Technical design note

Project name	15114 - Gavray Drive		
Design note title	Addressing Environment Agency Comments		
Document reference	15114-HYD-XX-XX-TN-FR-0001		
Author	Natasha Maxworthy BSc (Hons) GradCIWEM		
Revision	P01		
Date	27 June 2023	Approved	<input type="checkbox"/>

Hydrock received a review from the Environment Agency dated 14/02/2023 of a Flood Modeller-TUFLOW model used to assess the flood risk at Gavray Drive. This model was truncated to a site-specific model from an Environment Agency model of Bicester. This technical note will address each amber and red comment from the review for both the hydrology and the hydraulics elements.

Figure 1: Flood Frequency Analysis on the Langford Brook Gauge.

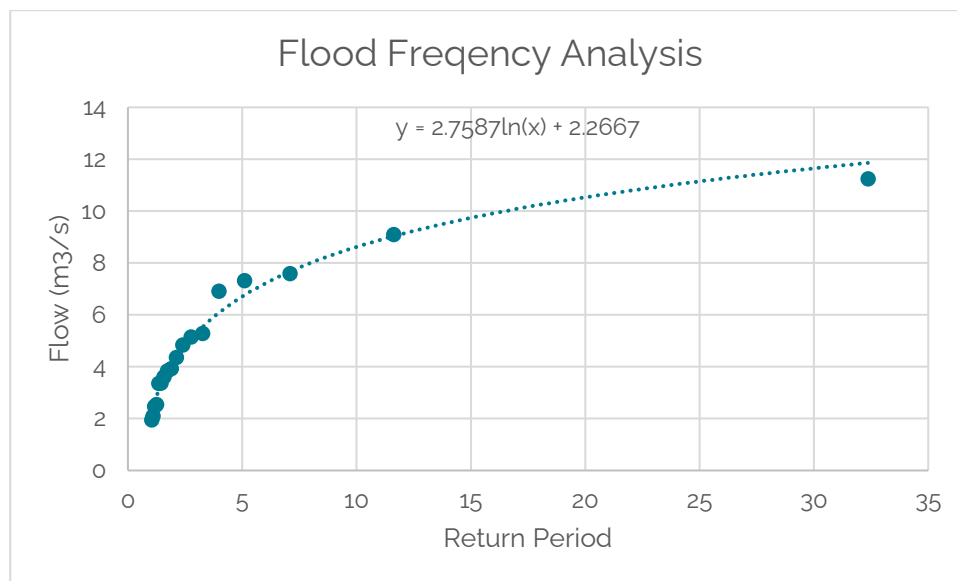
2.7 Please include plots and interpretation of the 3 - 5 largest events on record into the report. Can rating curves be created from looking at the recorded flood events, this was done in the previous study to help calibrate the hydraulic model to good effect and would reduce uncertainty in the estimates.

However, a flood frequency analysis using the Gringorton plotting position formula was undertaken to understand the return periods of the largest events at the gauge. A graphical representation of this can be found in Figure 1. Our statistical analysis showed that a 20-year return period has a peak flow of 9.21 m³/s. The flood frequency analysis showed that a 20-year return period has a peak flow of 10.53 m³/s. The similarity of these two flows gives confidence to the hydrological inflows into the model. Due to the short record of the gauge there is not high confidence in a single site analysis and therefore we can be more confident in our statistical analysis which also included information from other sites with longer records.

A flood frequency analysis on gauged data shows the highest flows occurring at the gauge was ~32-year return period. Therefore, the higher return periods used in this analysis will rely on a hydraulic model. The previous rating curve was generated using the hydraulic model for the higher flows and was accepted by the Environment Agency. Therefore, as the hydraulic model has not been altered, only truncated, this rating curve will remain acceptable.

Figure 2: 1m Lidar used to analyse topographical boundaries.

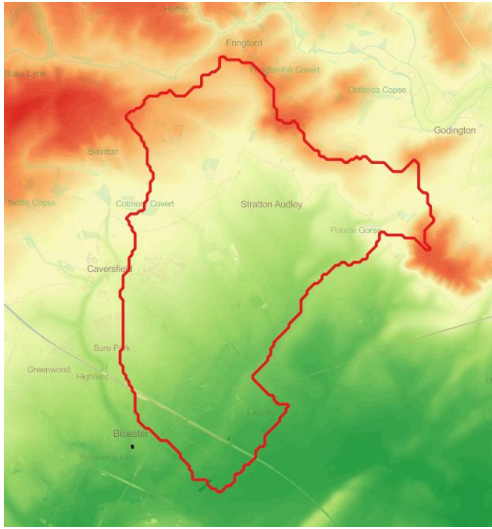
4.5 Please provide maps to illustrate that the catchment falls suitably within the topographical boundaries.

The catchments are unchanged from those within the original assessment (by EA). An assessment with the latest available 1m LiDAR shown in Figure 2 shows that the catchment delineated by FEH is correct.

Figure 3: Catchment Superficial and Bedrock Geology.

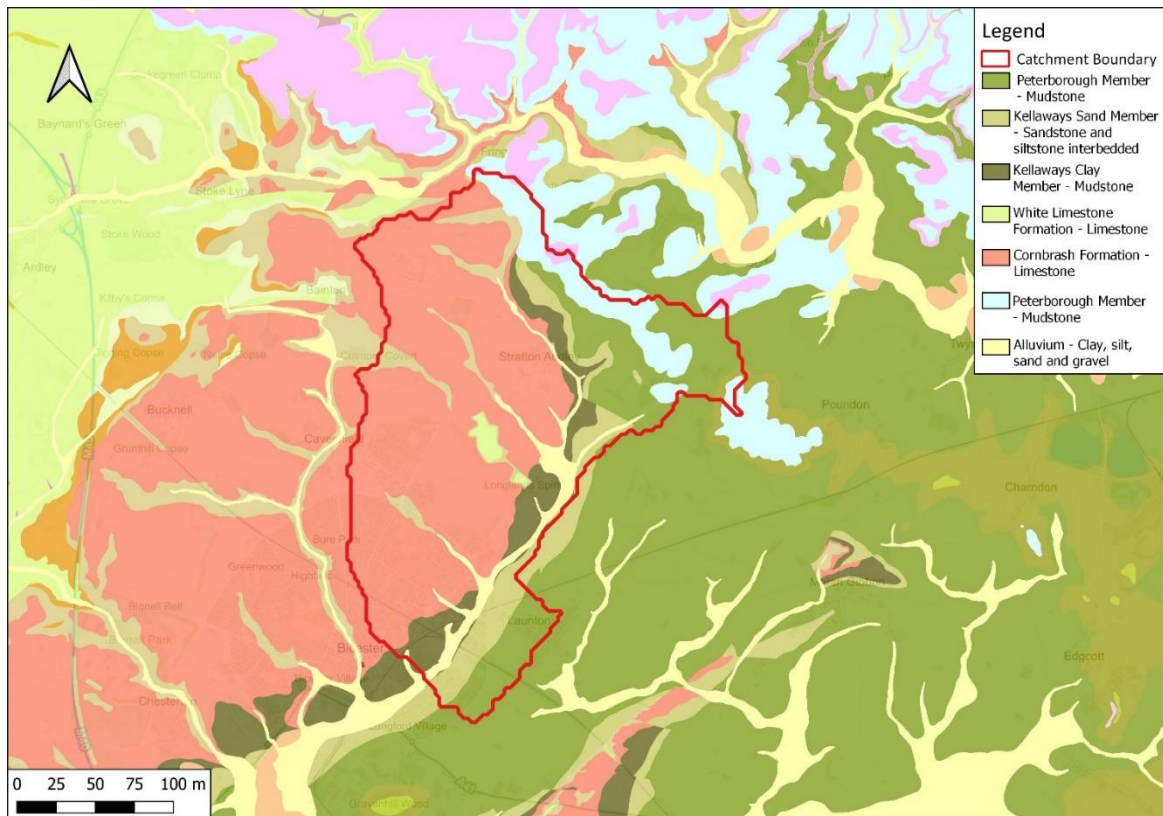
Provide geological maps to illustrate the distribution of bedrock and superficial deposits within the catchment.

Figure 3 shows the site bedrock geology to largely consist of mudstone, limestone and sandstone owing to a permeable catchment. This shows that the BFIHost of 0.629 is an accurate representation of the catchment. There are also superficial deposits of Alluvium along the Langford Brook owing to a mixed nature of permeability.

Figure 4: A map of the drainage network for the catchment.

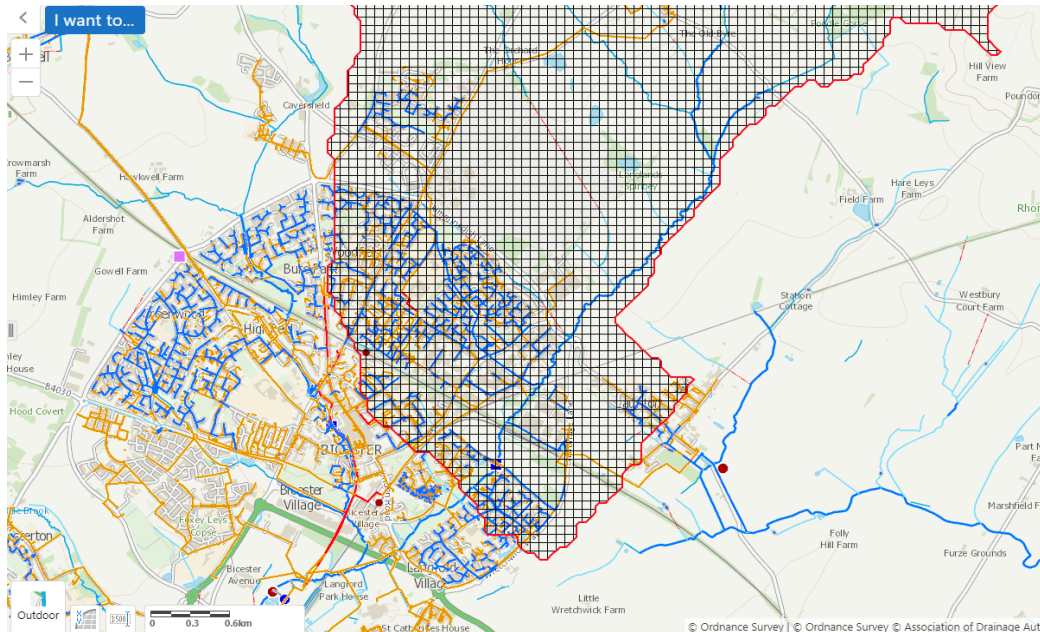
5.2 Please provide a map of the drainage network for the catchment and surrounding areas to show whether flows are being added or removed from the catchment. See screenshot for illustration of drainage network, this needs to be more robustly evidenced how checks have been carried out, currently it appears some flows may not be accounted for.

As detailed in the response to 4.2 a check of the sewer mapping has been undertaken. This confirmed a small area of cross catchment flows had been introduced (to the west) but that an area which was shown by the generated catchment area was not 'in catchment' and could be removed.

Figure 4 displays the plan and a check with Thames Water has confirmed this is accurate.

Figure 5: Summer Profile for the LA.3 node.

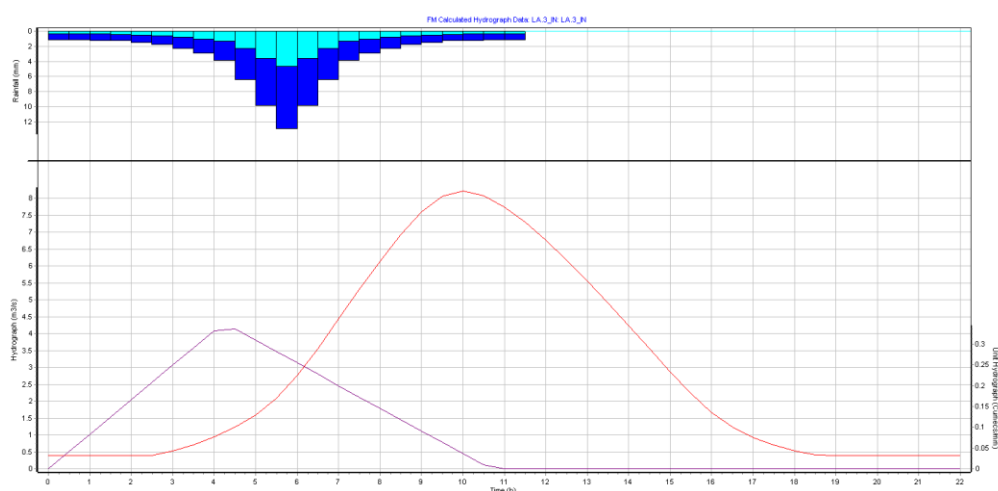
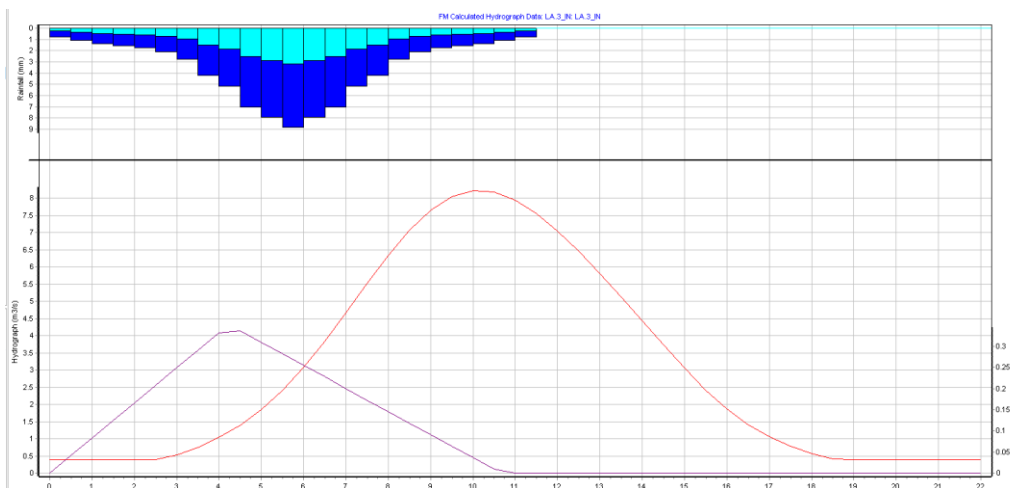
8.5 Please consider assessing whether a summer duration may be more appropriate for this catchment and provide explanation for the final choice of rainfall profile. Provide evidence to support your decision making.

This has been assessed and the summer profiles for each FEP has been used. This profile was deemed suitable as it a moderately urbanised catchment and therefore a summer thunderstorm is typically the flood causing mechanism. However, this does not cause any significant change to the hydrograph shapes an example of this is shown in figure 5 and 6, therefore there would be no change to flood extents.

Figure 9: Hydrological Inflows at the Upstream Node LB_US. 100-year+ CC in Green and 1000 year in Red.

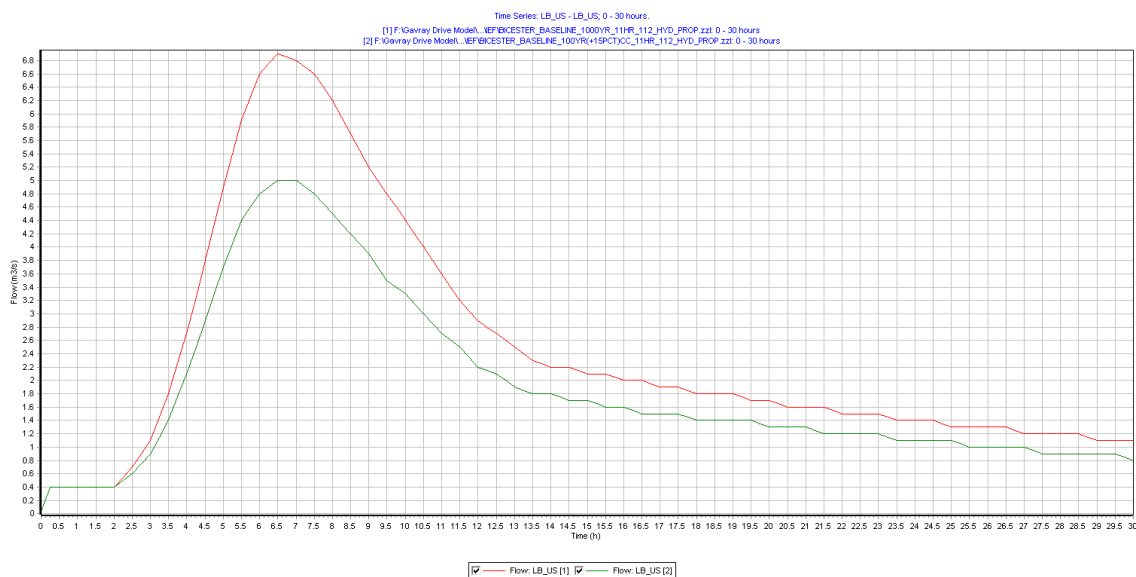
4.2. The original study provided two additional inflows within this catchment, please provide explanation for why these are no longer required. An unusual hydrograph shape can be seen throughout the model with an initial sharp rise in stage/flow before plateauing for several hours. Please investigate and amend the hydrograph so it does not have the plateauing. Additionally, the model run scenarios have been set up incorrectly, the graph included hopefully illustrates the issue but the 0.1% hydrograph has been applied to the 1%CC model runs and vice versa and should be re-run so that the model runs correspond correctly.

Figure 9 shows that shows the 100yr+CC (green) and 1000yr (red) where the 1000-year flow is larger. The plateauing of flow is due to the minimum flow set on the inflow of 0.4 in order for the model to run during low flows and only occurs for 2 hours, therefore does not affect the maximum flood extents or depths.

Figure 11: 2D Downstream Boundary location.

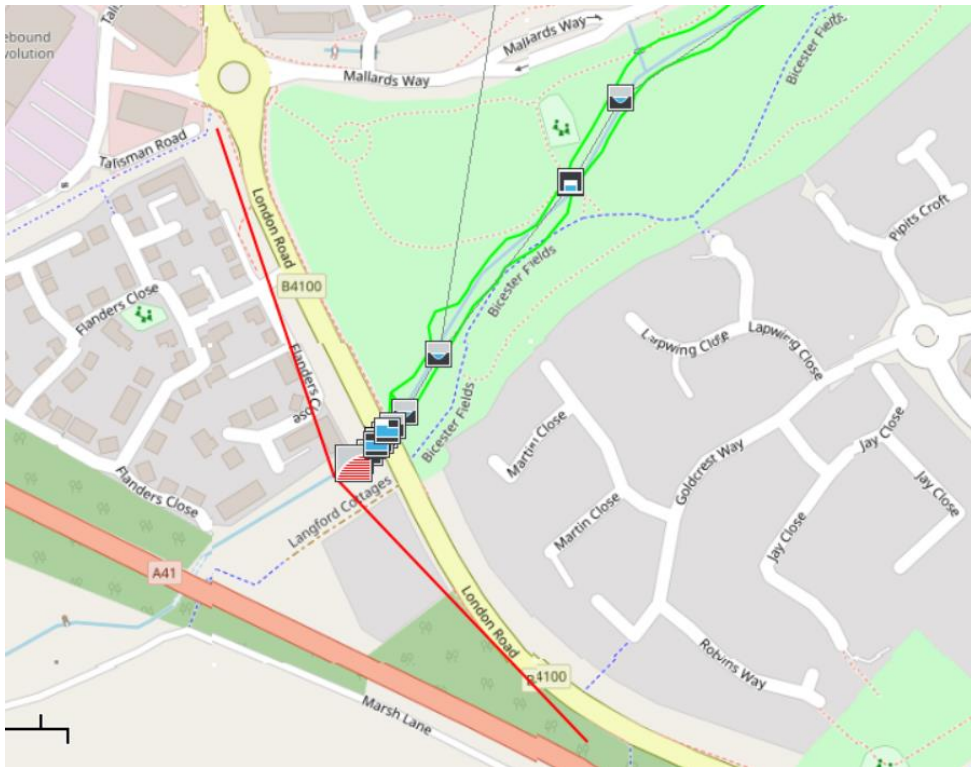
4.3. The downstream boundary has been modified with the model truncation. The new downstream boundary has been placed in an unusual place, normally this would be placed at a control structure where possible that cannot be bypassed by out of bank flows. In this instance the DSB is bypassed in the 2D domain where HQ boundaries have been placed at the edge of the domain, to take flows out of the model. Please provide explanation for the schematisation of this DSB and why the bridge just downstream could not be used as a suitable downstream limit for the model.

Sensitivity testing has been carried out for +/- 20% slope, this shows some minor difference in levels at the site of interest, have these been replicated for the 2D boundary as this is also taking flow out of the model. It is recommended that the 2D boundary is realigned with the B4100 so it is not taking flow out of the model and all flows are routed correctly through the 1D as normally flow would not be leaving the model in the place where the 2D boundary has been schematised.

Figure 10 displays that the downstream boundary has been changed to below the B4100 as suggested and shown in Figure 11. No water escapes from this boundary.

Figure 12: New results showing the code layer has been aligned to the DTM.

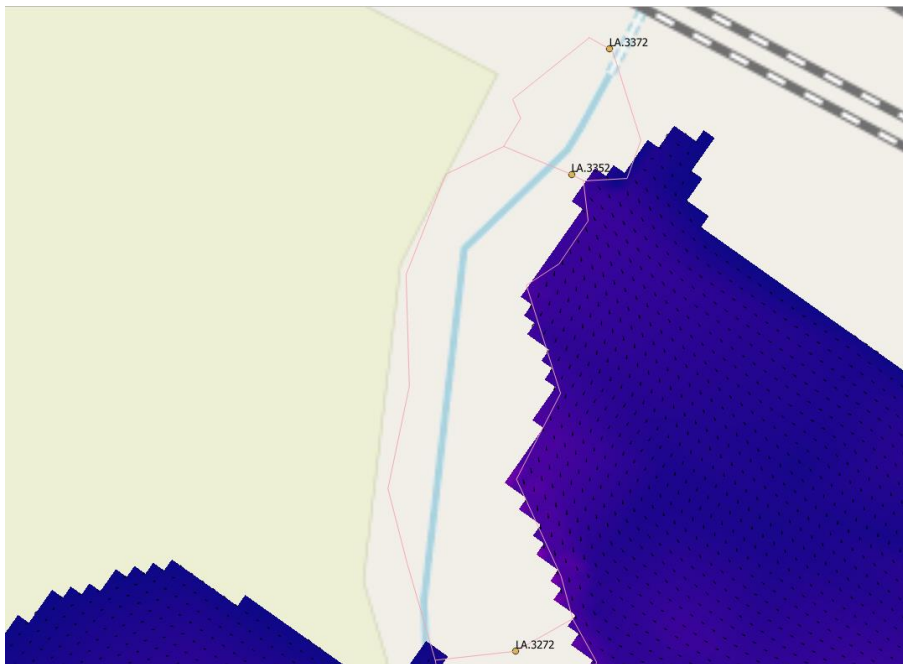
12.2. See item 7.4, it would be preferable to lower the grid resolution, if possible, to improve channel representation with less 1D-2D interaction which could improve model stability.

See screenshot for example of flows exiting 1D and re-entering due to code layer not being aligned with the DTM.

The grid resolution has been lowered to 2m and the code layer has been checked and aligned with the DTM. Figure 12 shows that the flows do not exit and re-enter the 1D.

Figure 13: BMP File of the 100 year plus 15% CC.

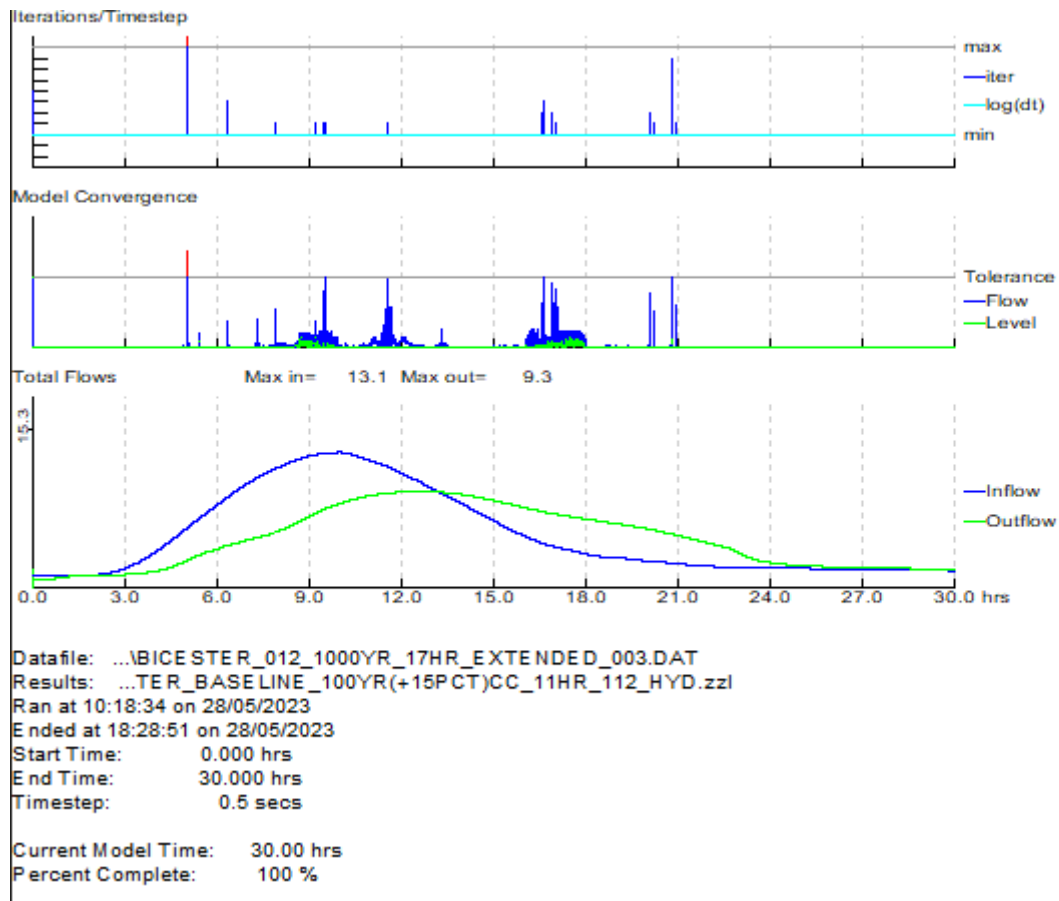
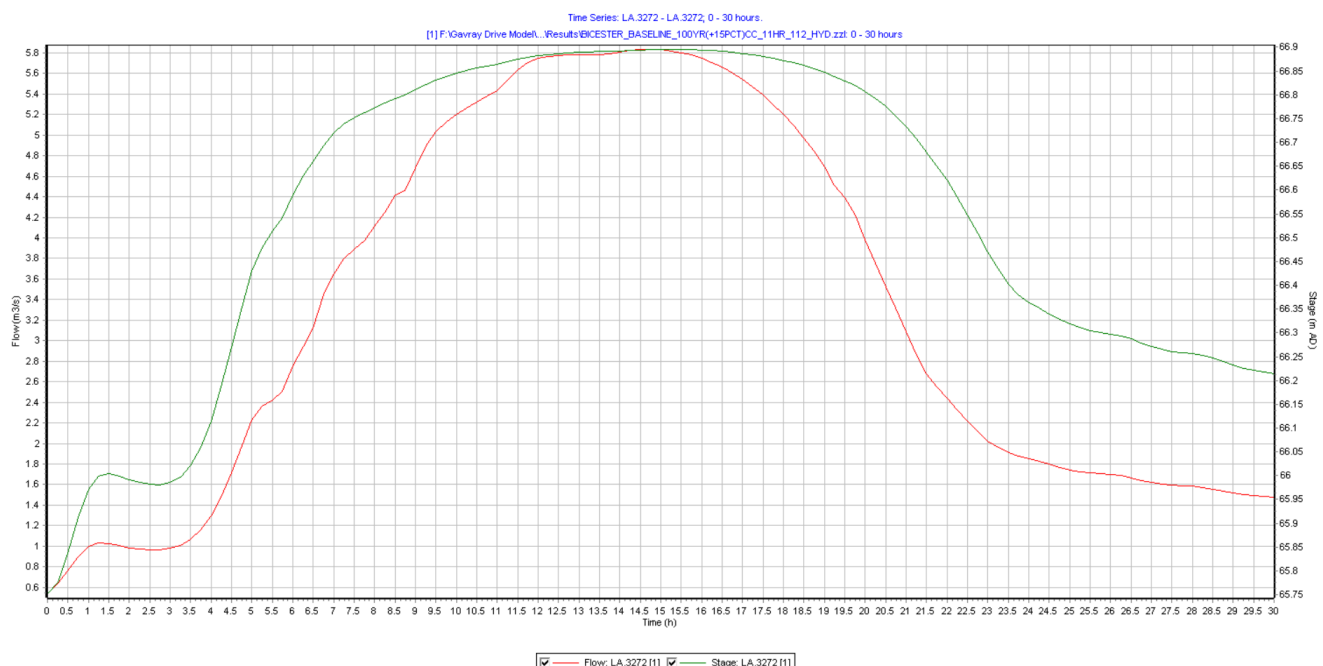
13.2. Model convergence has been improved however there is still significant convergence, this is not above the threshold. Consider investigating what is causing these stability issues, it is apparent when viewing the animation of cross sections that there are frequent stage changes which is unrealistic and makes it difficult to judge.

Whilst there are still some convergence issues under the threshold (figure 13), the animations and time series (figure 14) show that the stage and flow are smooth and the convergence does not impact the maximum extent.
